Series EZGO - 1206 Replacement
Wiring Diagram

SIZE DOCUMENT NO. Doc100-043
REV. A

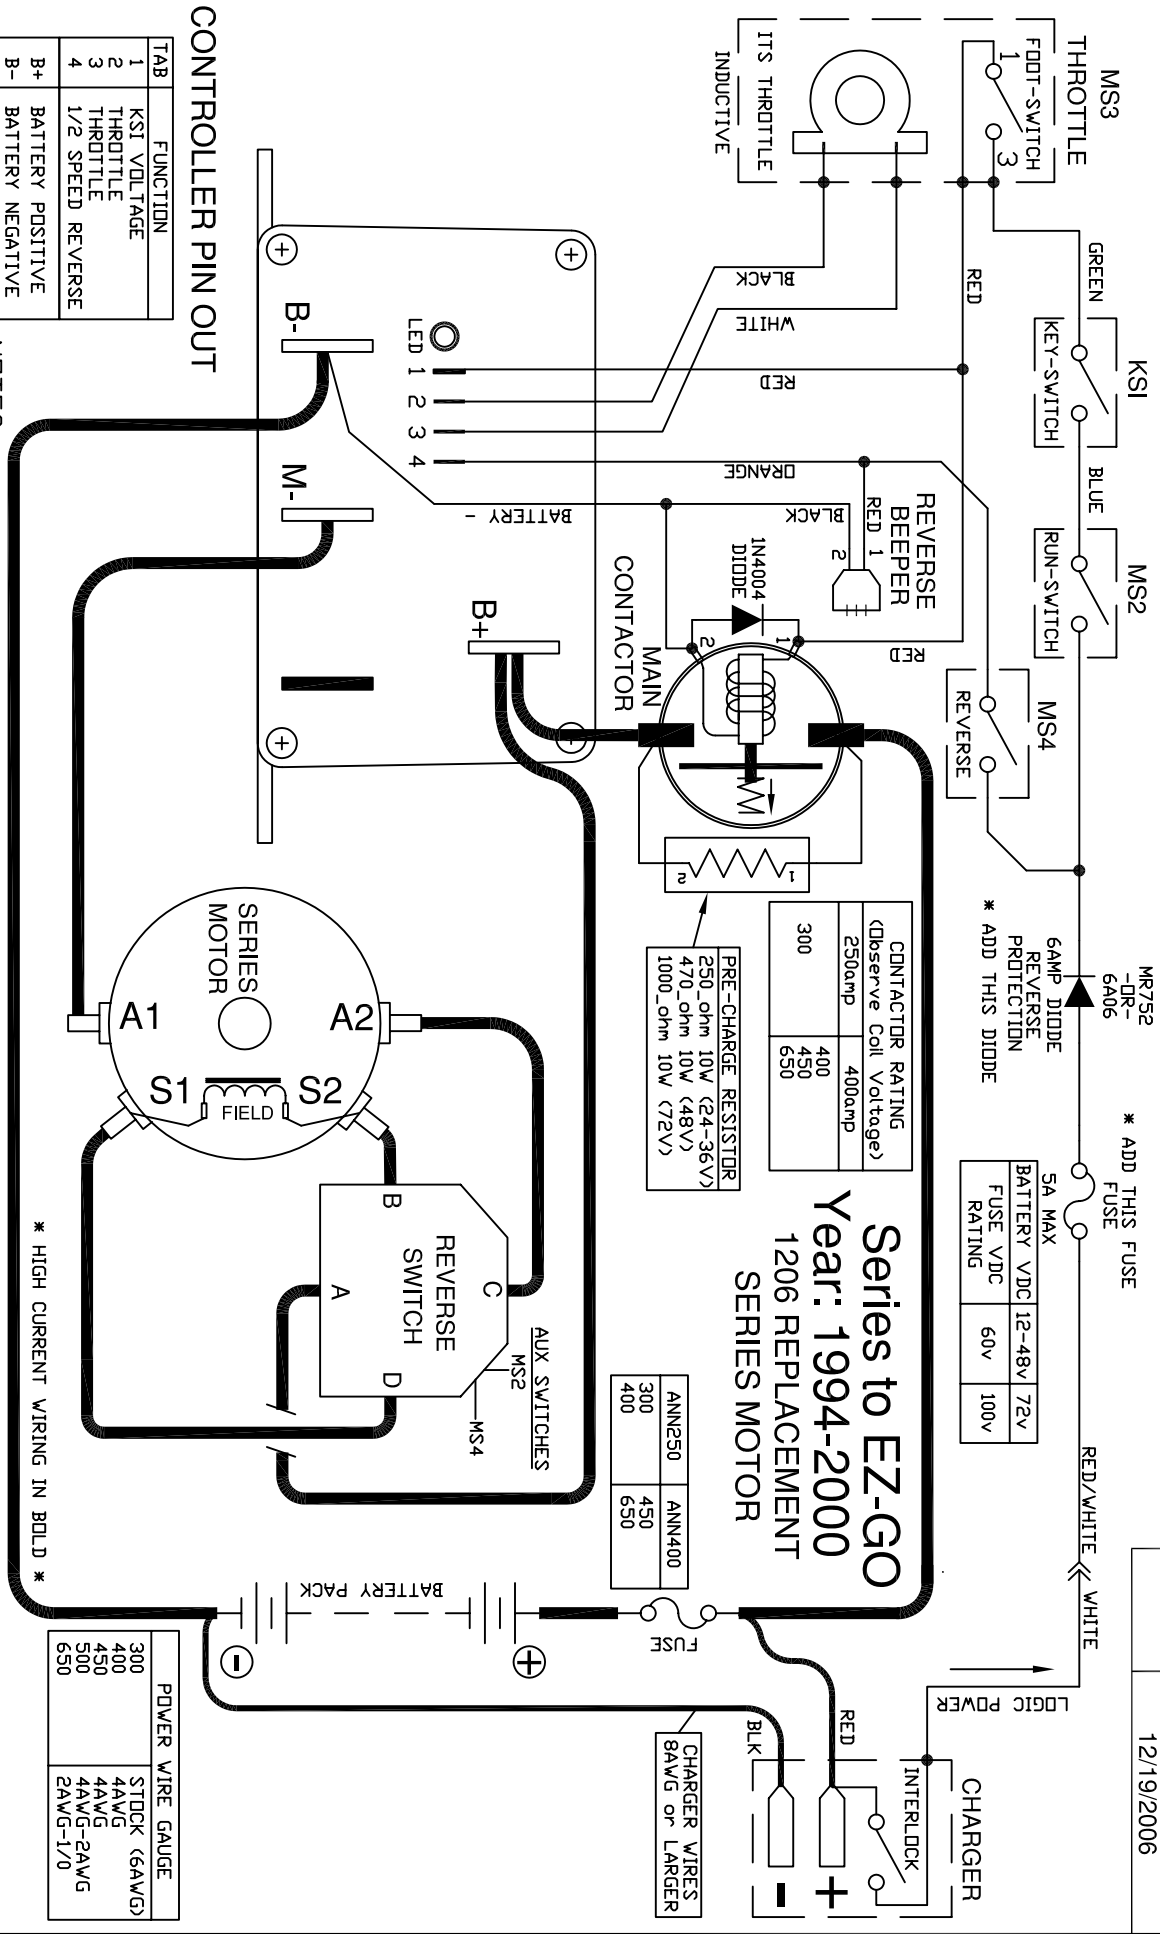
DIODE NOT SHOWN ON ORIGINAL SCHEMATIC

MR752 * ADD THIS FUSE
-DR-6A06
